Re: Florida Power & Light Company
Proposed Turkey Point Units 6 and 7
Docket Nos. 52-040 and 52-041
Response to NRC Request for Additional Information Letter No. 037
(eRAI 5896) SRP Section - 02.05.02 Vibratory Ground Motion

FPL Response to NRC RAI No. 02.05.02-2 (eRAI 5896)

NRC RAI Number: 02.05.02-2 (eRAI 5896)

Re: Florida Power & Light Company
Proposed Turkey Point Units 6 and 7
Docket Nos. 52-040 and 52-041
Response and Response Schedule to NRC Request for Additional Information
Letter No. 037 (eRAI 5896) SRP Section - 02.05.02 Vibratory Ground Motion

Figure 6c. EPRI (FSAR Reference 242) Mid Continent 1Hz weighted mean attenuation curve for a magnitude 8 earthquake.

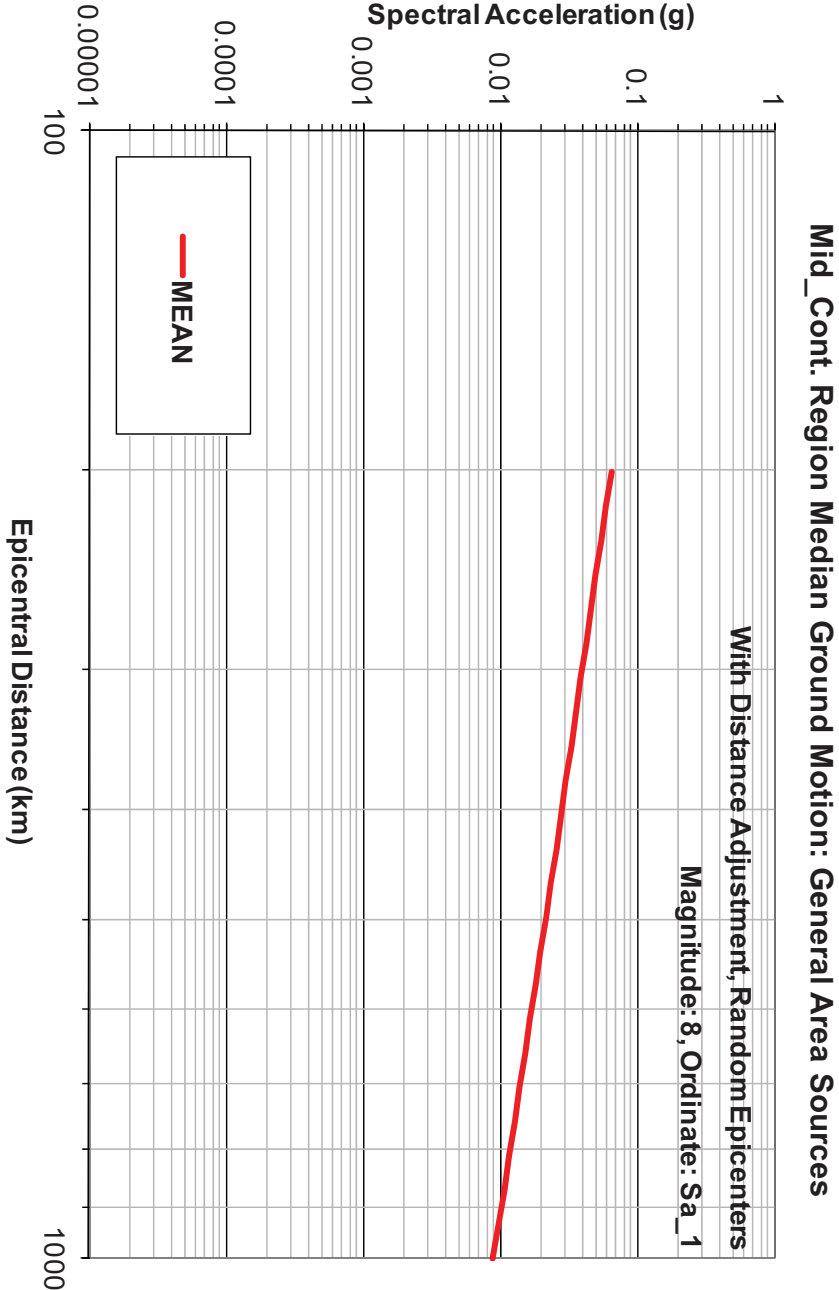
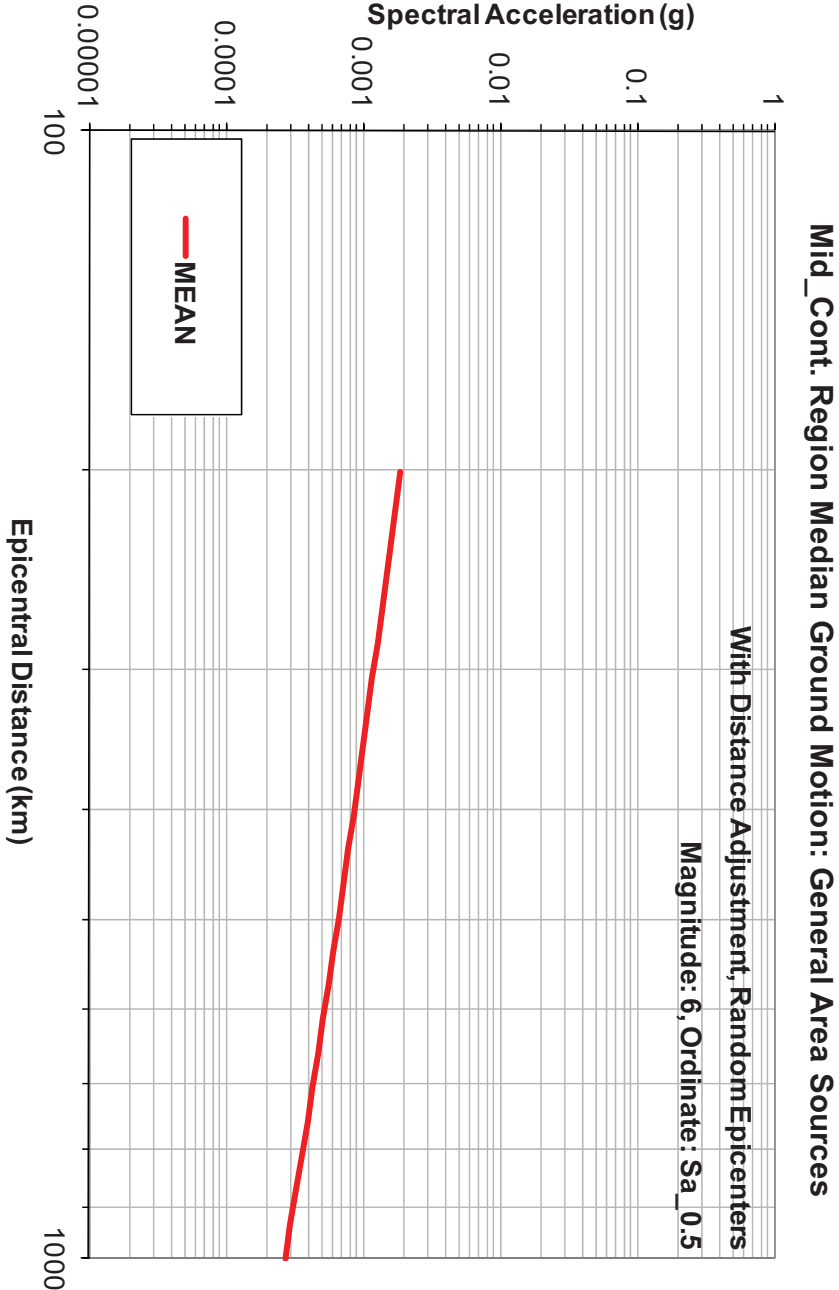
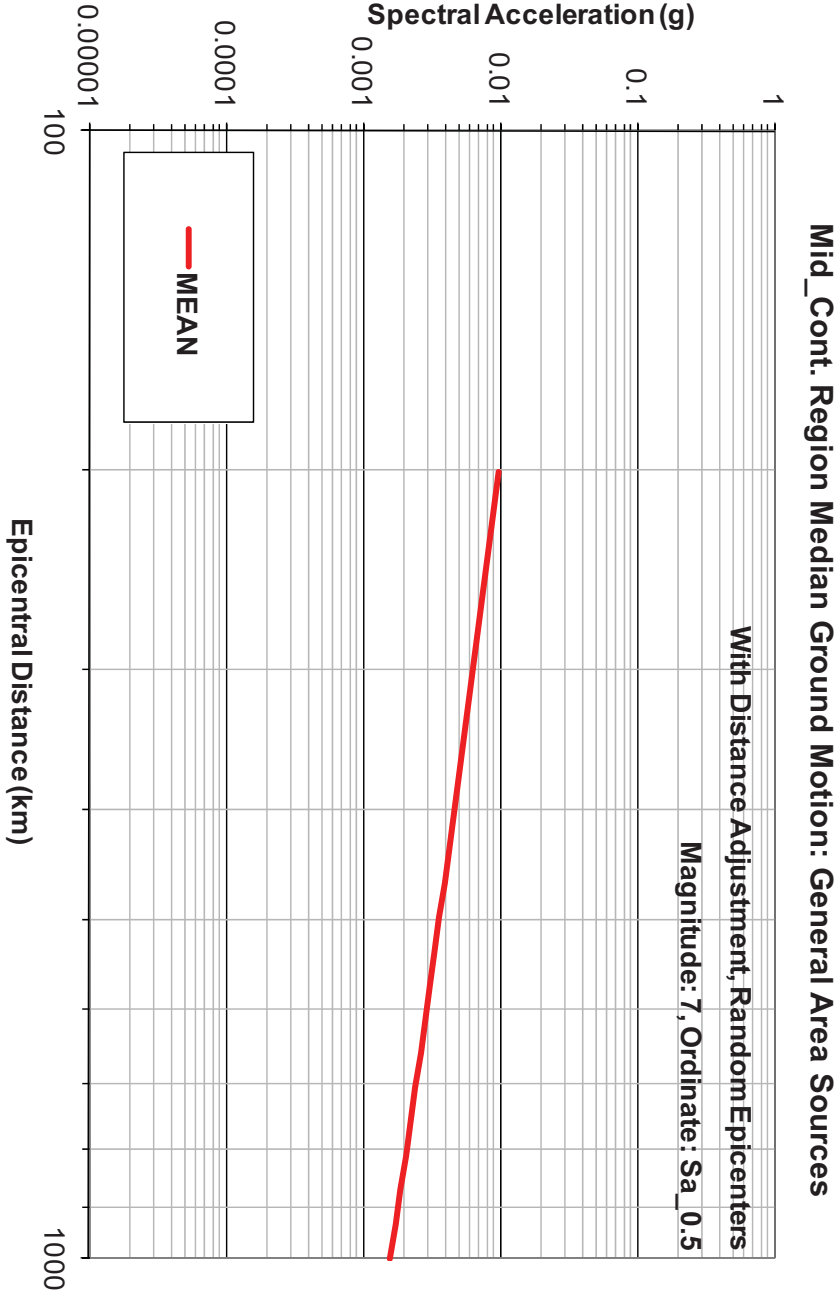
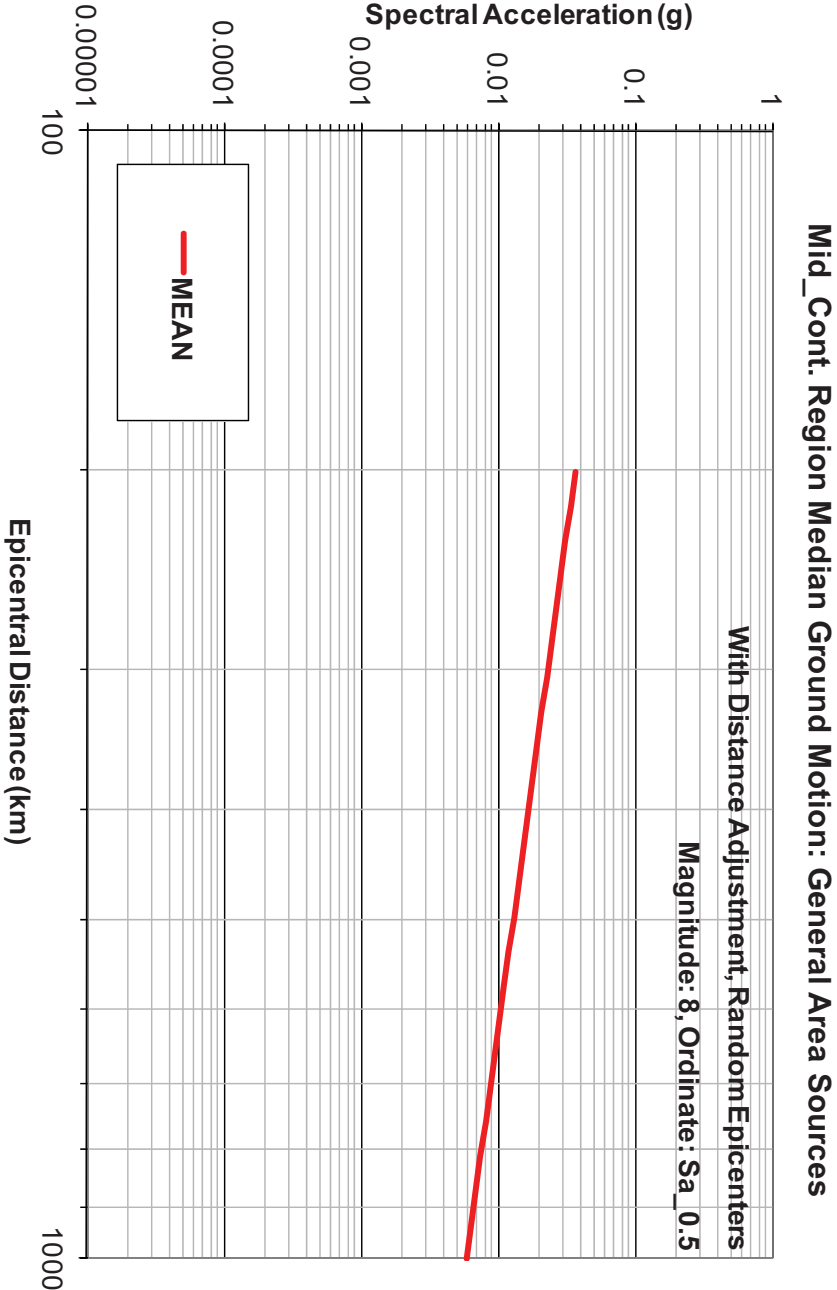
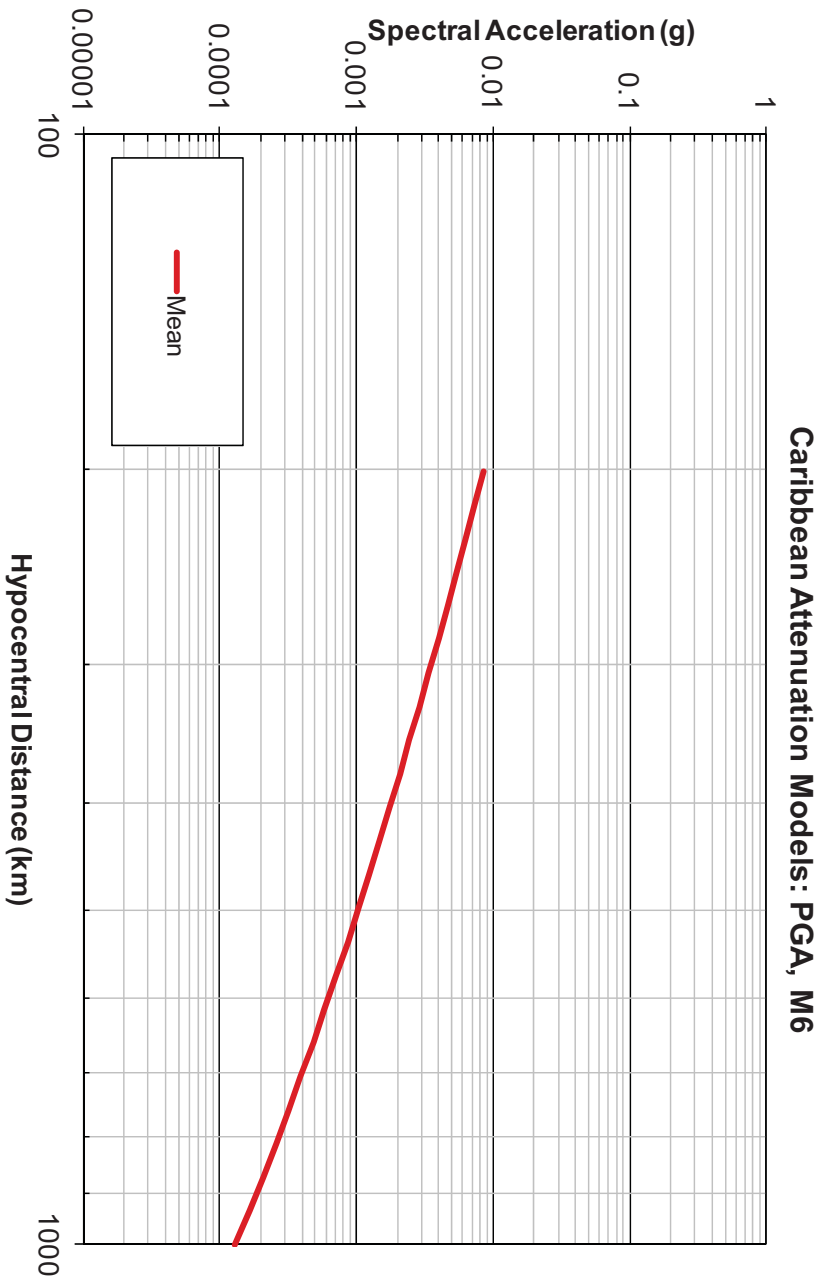
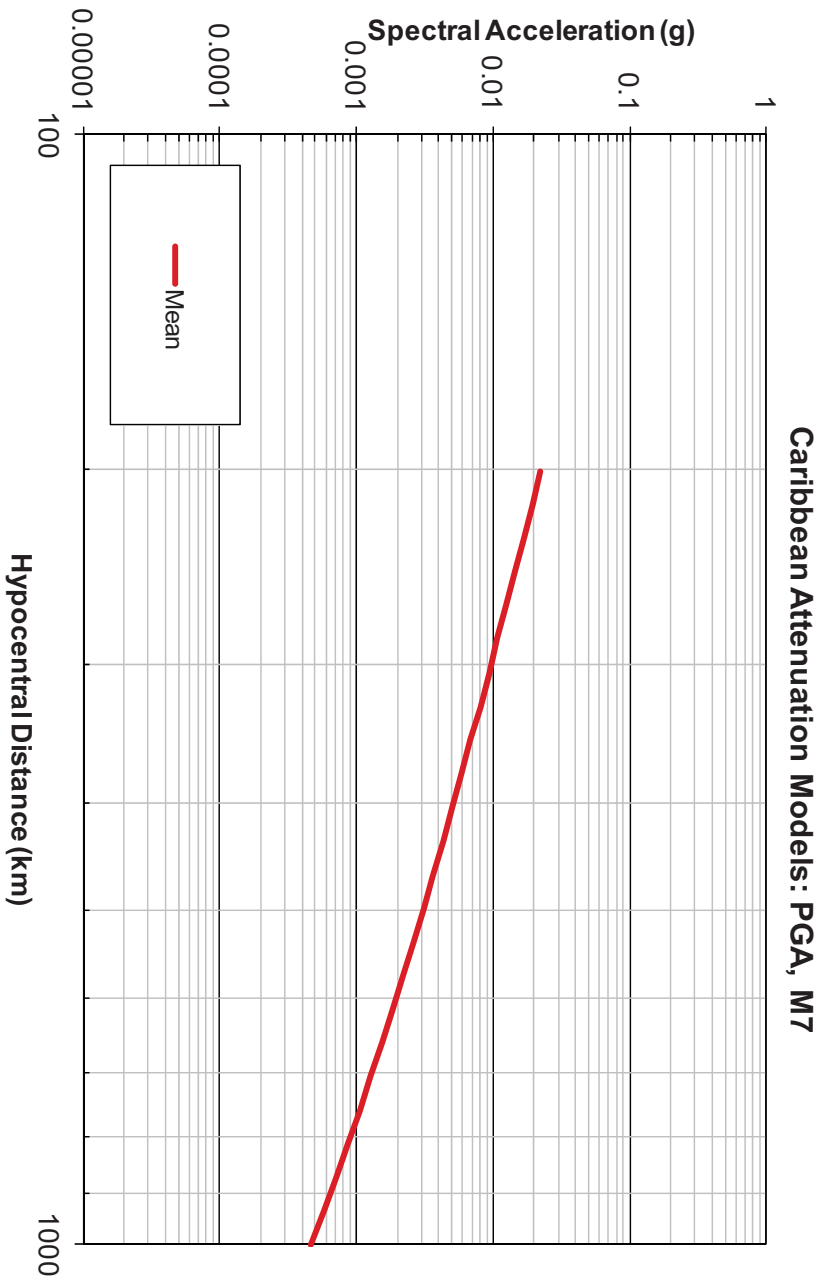
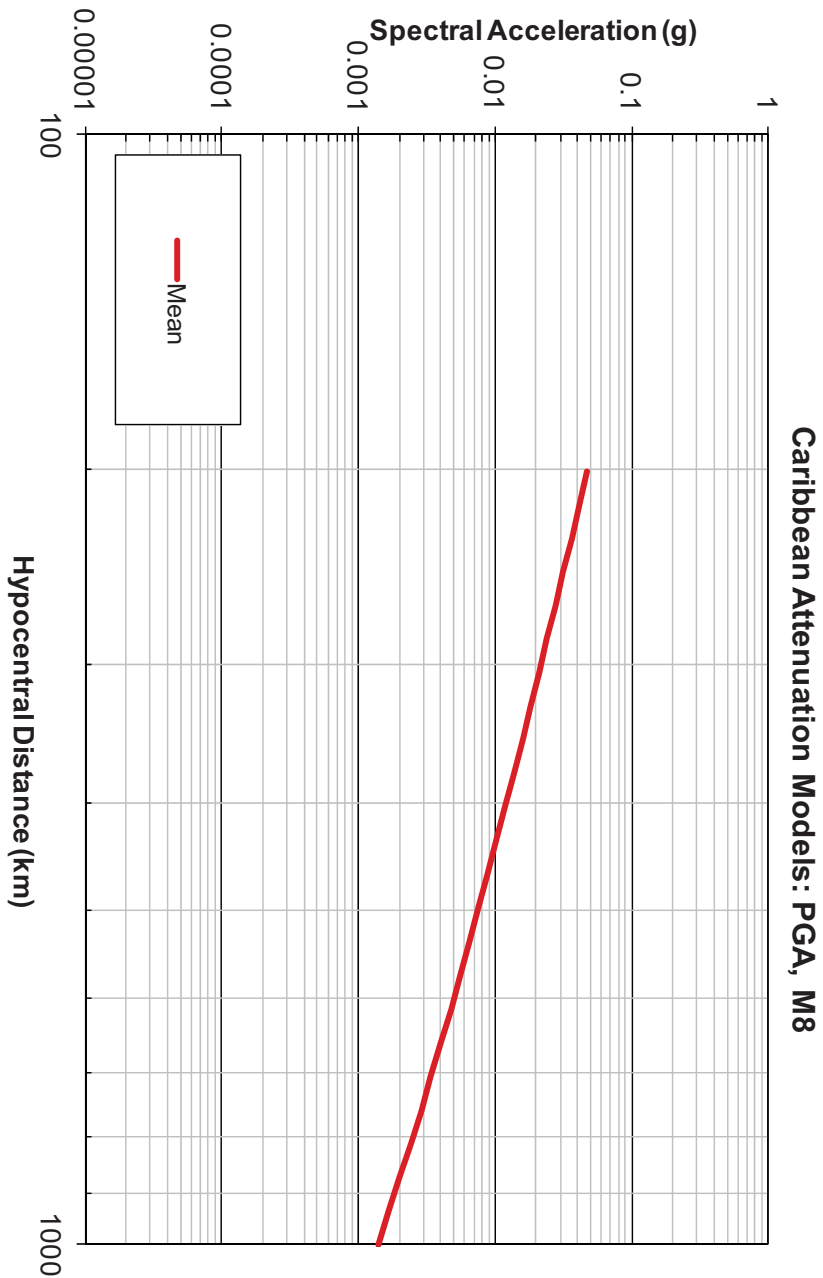
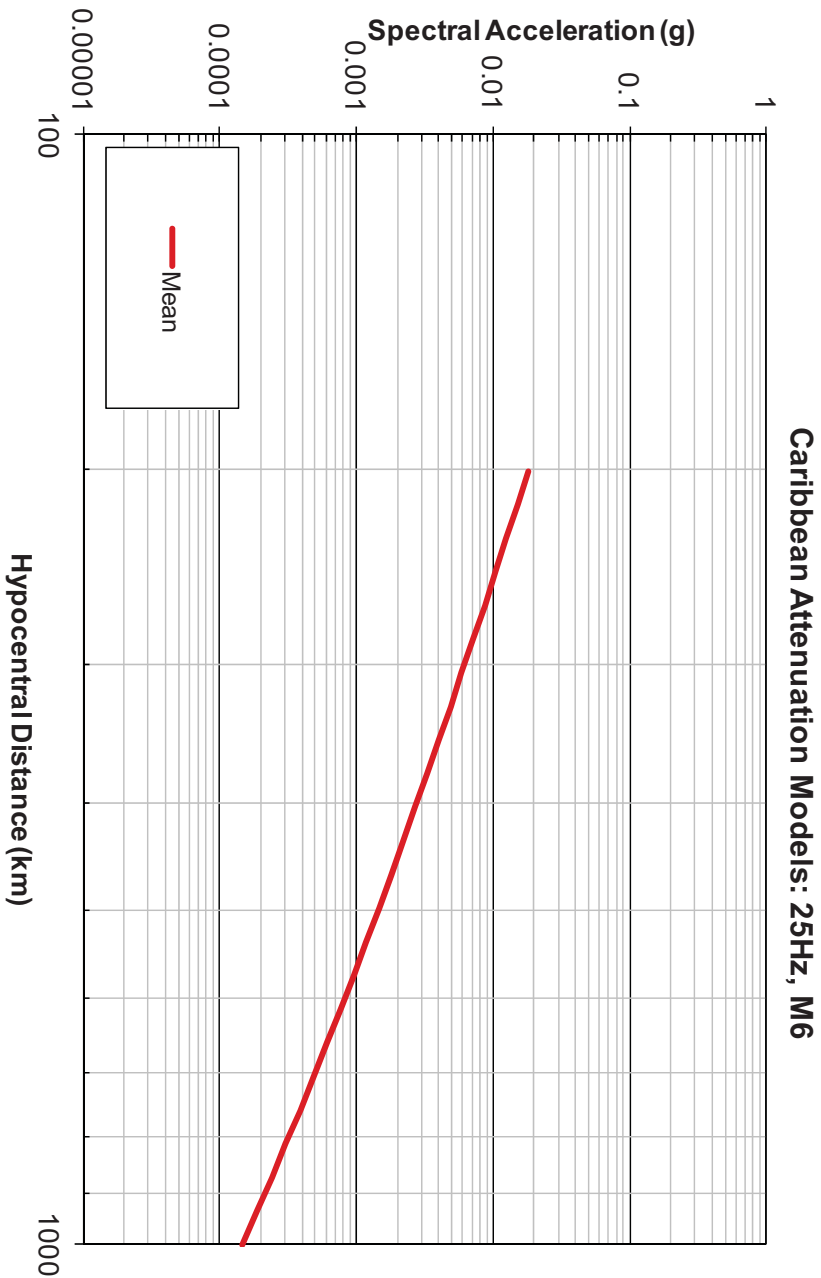
- d. In order for the staff to be able to compare the new Caribbean GMPEs with the 2004/2006 EPRI mid-continent GMPEs, please provide plots showing both ground motion models for earthquake magnitudes of 6.0, 7.0, and 8.0 in the distance range of 200 km to 1000 km at all seven frequencies defined in the EPRI 2004 and 2006 GMPEs.

Ground motion attenuation curve plots are provided for the EPRI (FSAR References 242 and 203) and Caribbean ground motion prediction equations (GMPEs). Note that EPRI (FSAR Reference 203) is only a recommendation for the associated aleatory uncertainty and therefore does not impact the comparison plots of the weighted mean ground motion

attenuation curve. The plotted mean attenuation curve is the weighted mean of the individual median attenuation curves as defined in EPRI (FSAR Reference 242). These attenuation plots are provided for three specific moment magnitude (M_w) values: 6, 7, and 8 for distances between 200 km and 1,000 km. Note that the EPRI (FSAR Reference 242) ground motion attenuation model is defined as a function of epicentral distance, whereas the Caribbean ground motion attenuation model is defined as a function of hypocentral distance. However, because the closest distance is 200 km, the difference between the epicentral and hypocentral distances would be less than 1% for a typical crustal depth of 10 km and even smaller for larger distances out to 1,000 km.

The weighted mean ground motion attenuation curves for the EPRI (FSAR Reference 242) model are given in Figures 1 through 7 for the three magnitudes and seven spectral frequencies requested in the RAI. The weighted mean Caribbean ground motion attenuation curve plots for the same suite of magnitudes, distances, and spectral frequencies are shown in Figures 8 through 14.
